CITY OF GLENDALE, CA

DESIGN REVIEW STAFF REPORT – SINGLE FAMILY

1201 San Luis Rey Drive, 91208

PADR-001035-2023

SITE PLAN & ROOF PLAN

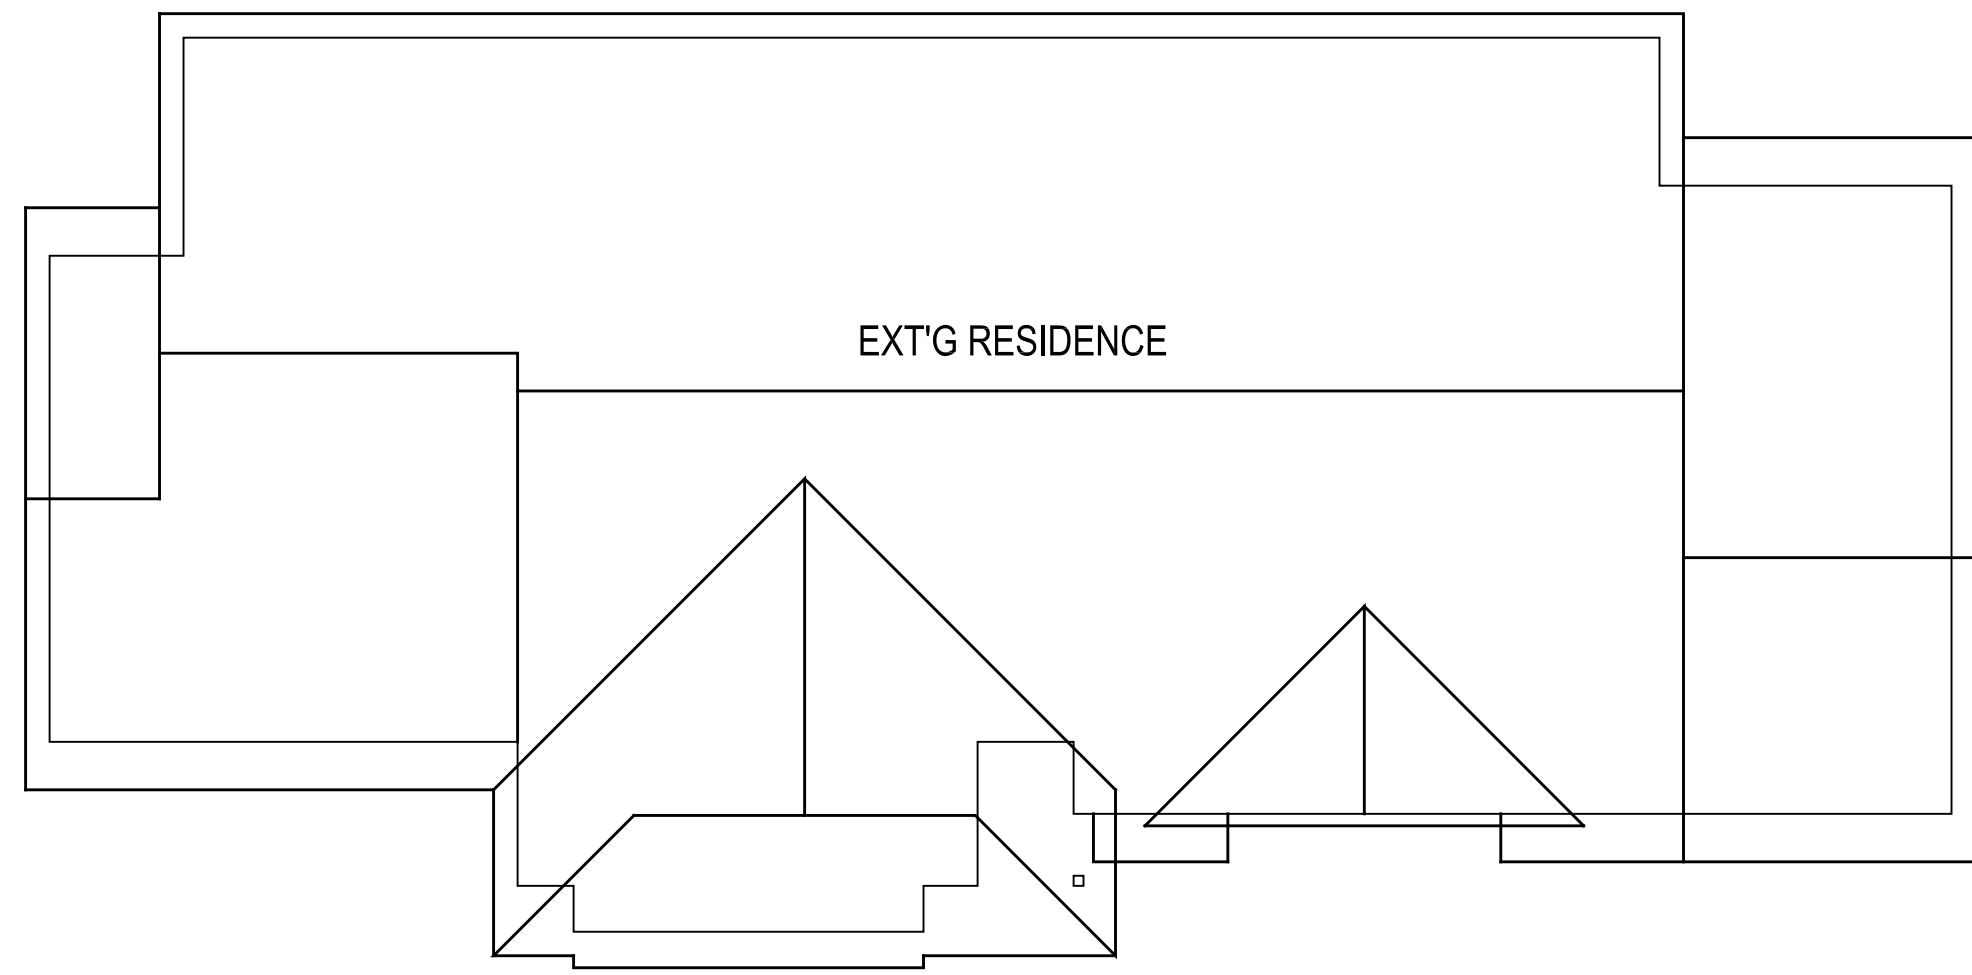
Provide proposed roof plan for Planning review.

Existing driveway includes brick to match brick cladding on the house. If this is to be replaced to match proposed Stone siding, please provide details on the plans for Planning review.

PROPOSED FLOOR PLAN / DOOR & WINDOW SCHEDULE

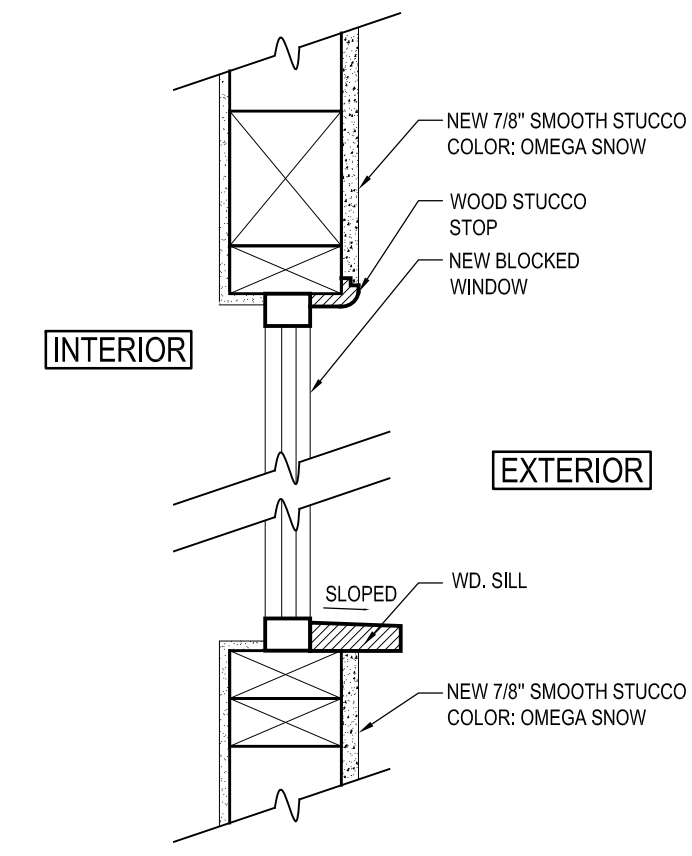
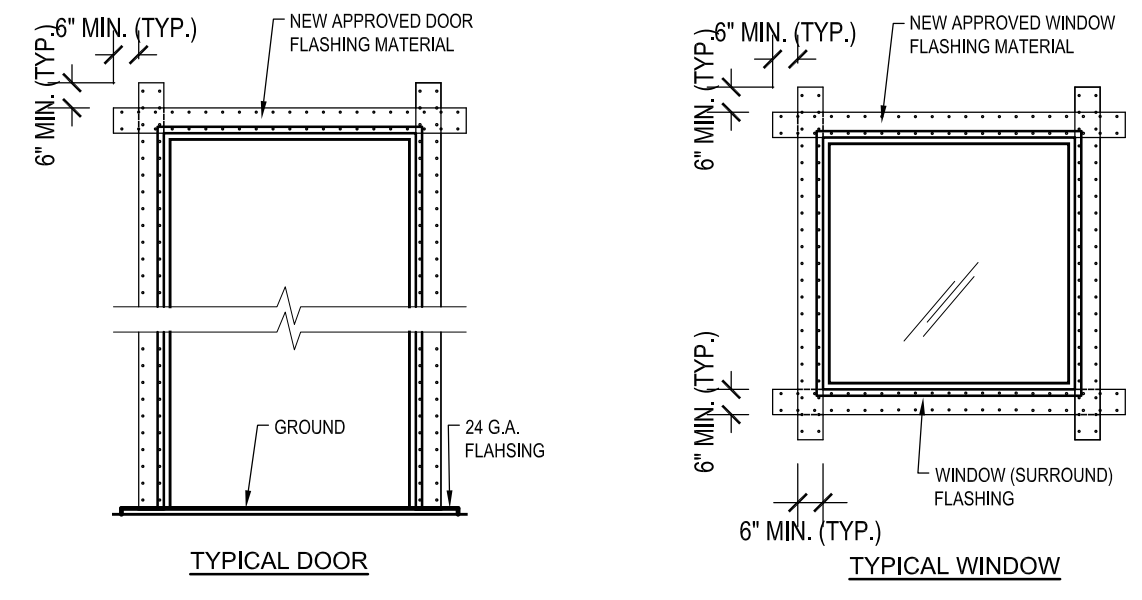
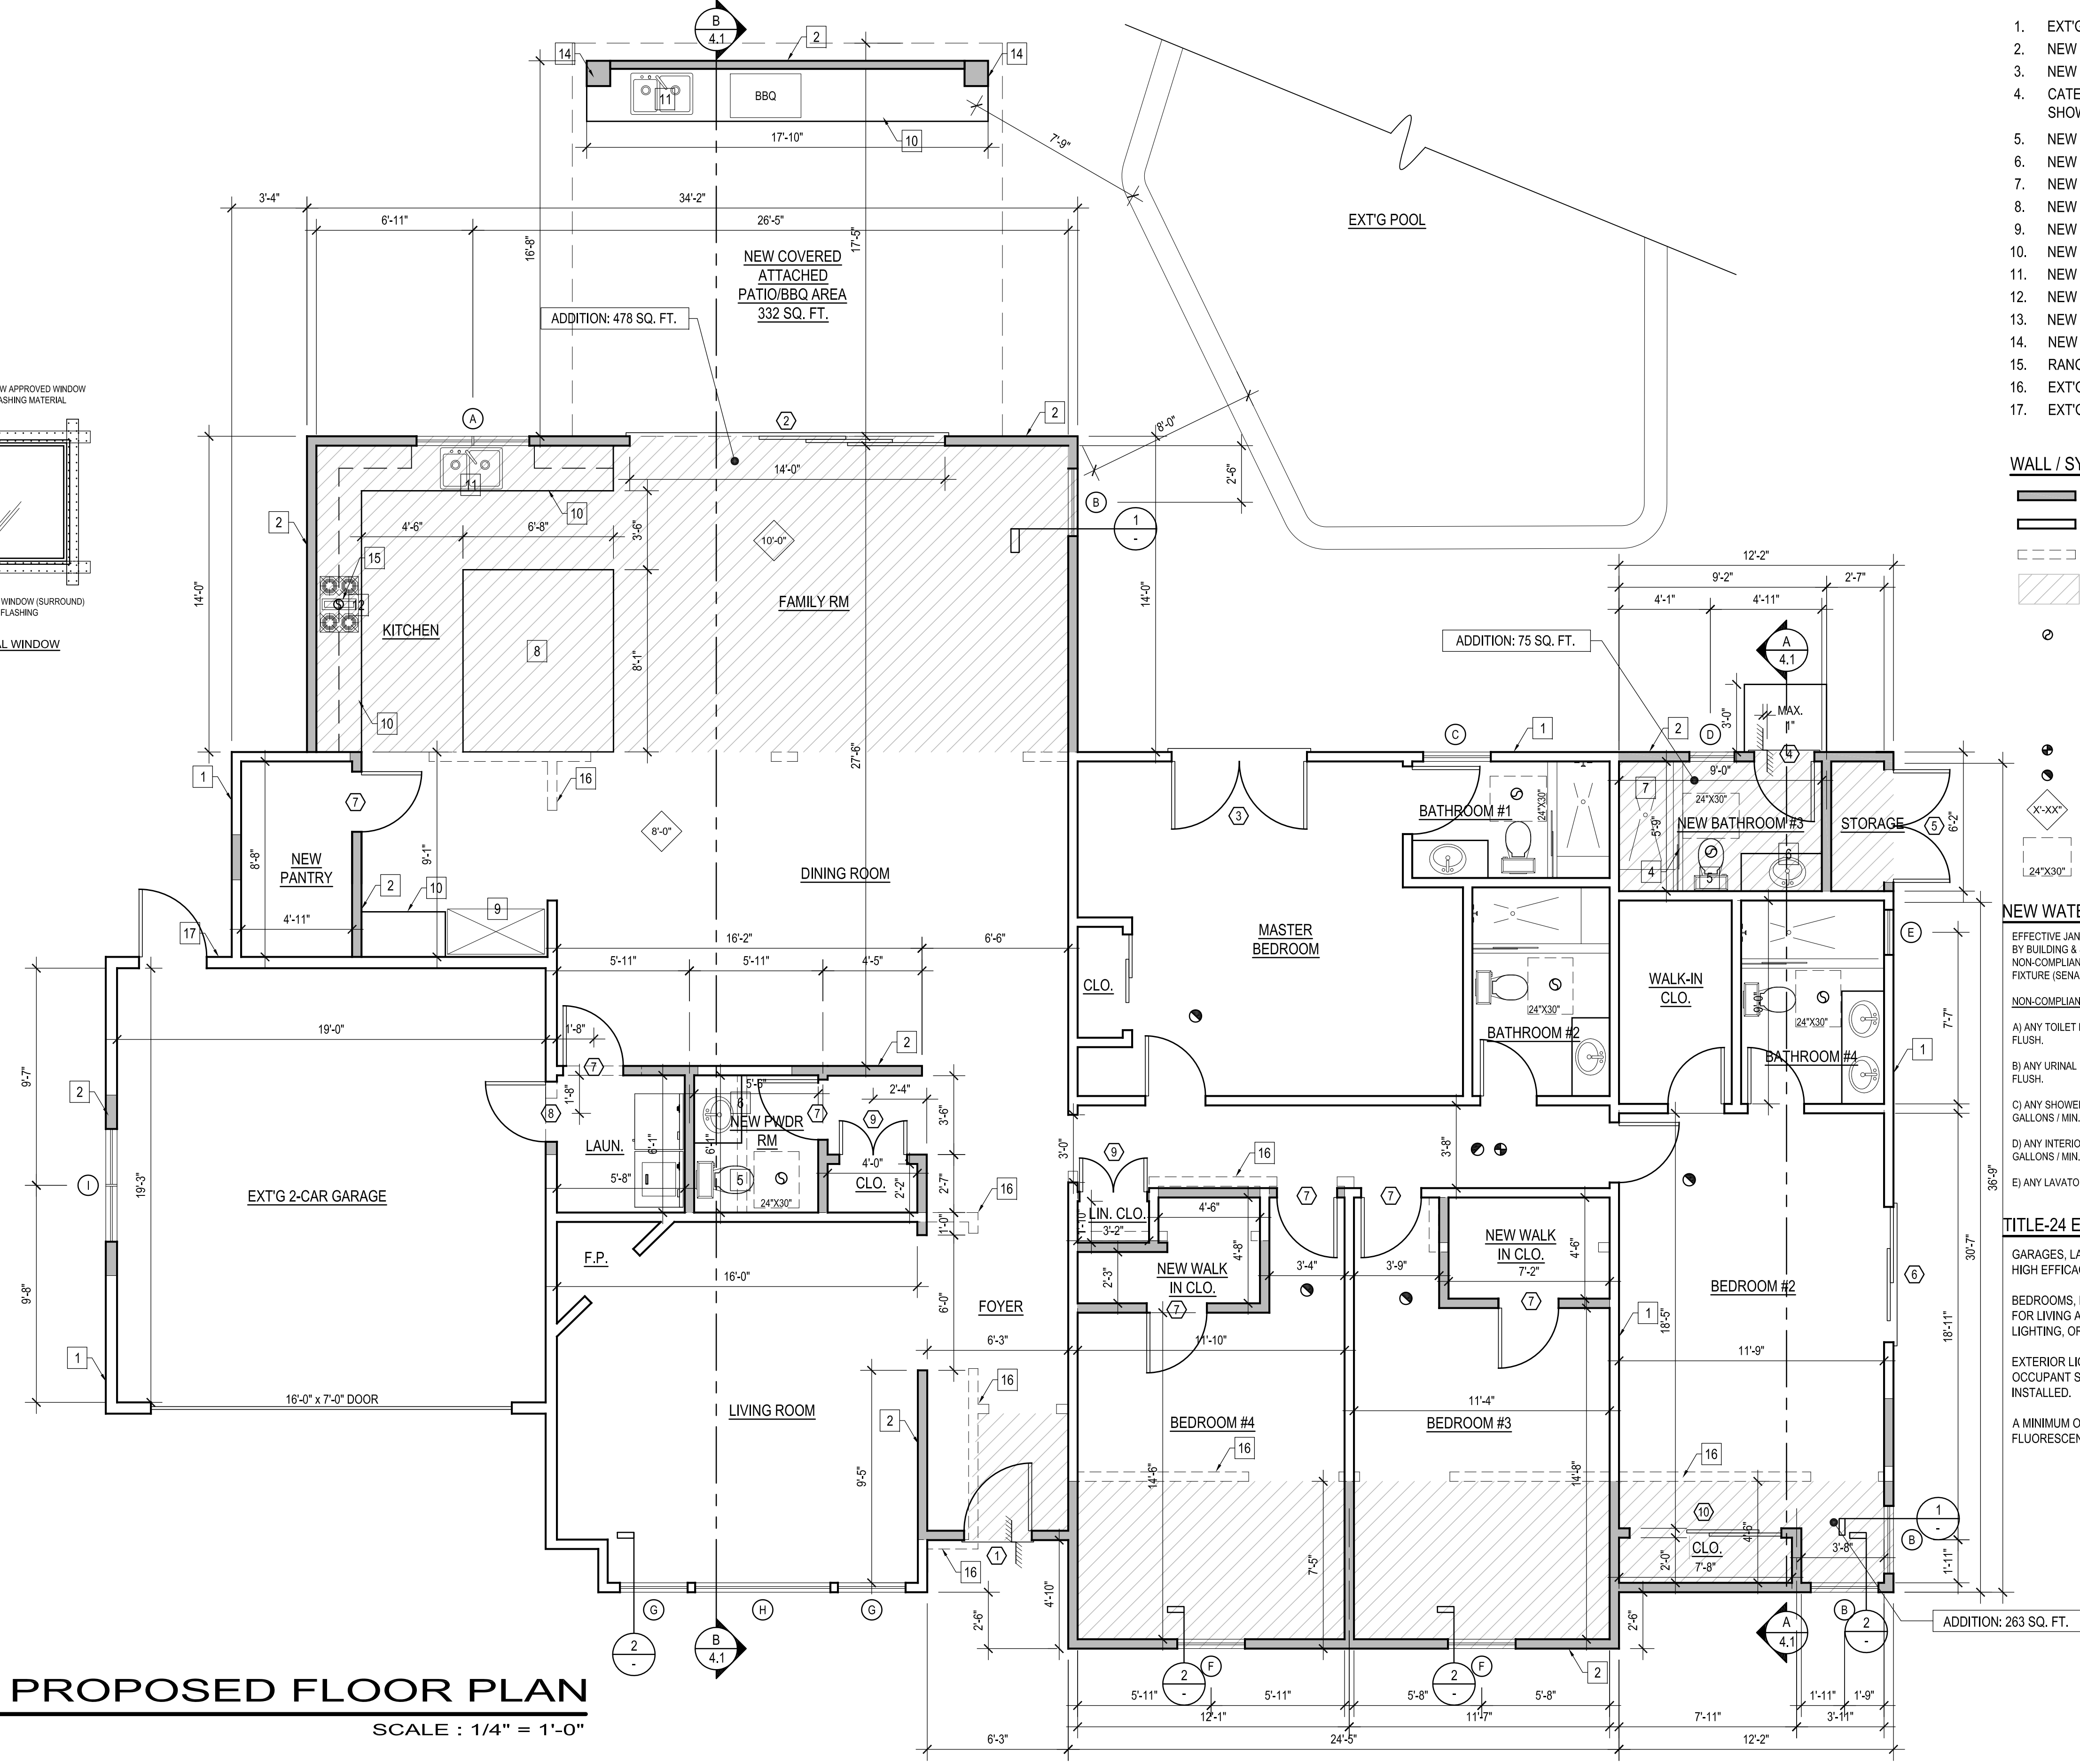
Revise Window Schedule to replace any visible slider windows with hung or fixed operations.

1. That a cut sheet of the proposed front door be provided for Planning Review
 2. That the Window Schedule be revised to replace sliders where visible from the street with hung or fixed operations.
 3. Provide details of proposed driveway if materials will be revised to match new design of the house.
-
